BCA Capability Statement

Chisholm Community Centre

Cnr of Heritage Drive and Tigerhawk Drive Chisholm NSW

Reference: N230044

Figure 2: Fire Seperated Plant and Equipment

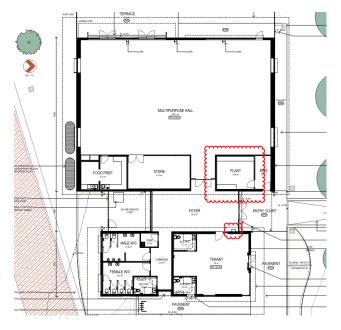
Only a single plant room is noted on the documentation where it contains switchboards which sustain emergency equipment, or other services noted under this clause fire separation is to be provided and shown on the documentation.

Where the main switch board sustaining emergency equipment is located in the proposed plant room it will need to be fire separated off from the remainder of the plant room. Architect to review and monitor for compliance in the design in this regard.

Figure 3: Available Exits

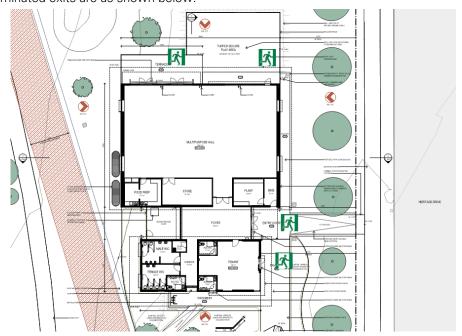
Comment: Compliance is achieved not less than two (2) exits would be required from the building based on more than 50 persons being accommodated.

A single exit will be sufficient to serve the tenant space. Egress via the tenant space from the community center is not permitted under this clause.

The nominated exits are as shown below.

Figure 4: Height of Window to be Increased

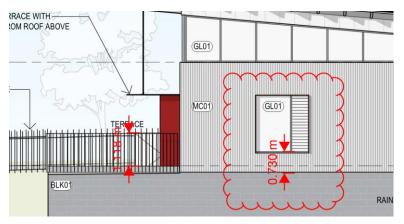
Balustrades are to be documented to all areas where the distance to the surface below is more than 1m typical example below, particular attention needs to also be paid to any openable

windows which are less than 1m FFL which will be deemed a barrier and need to comply with the compliance with this clause. Details to be provided along with the application for Construction Certificate.
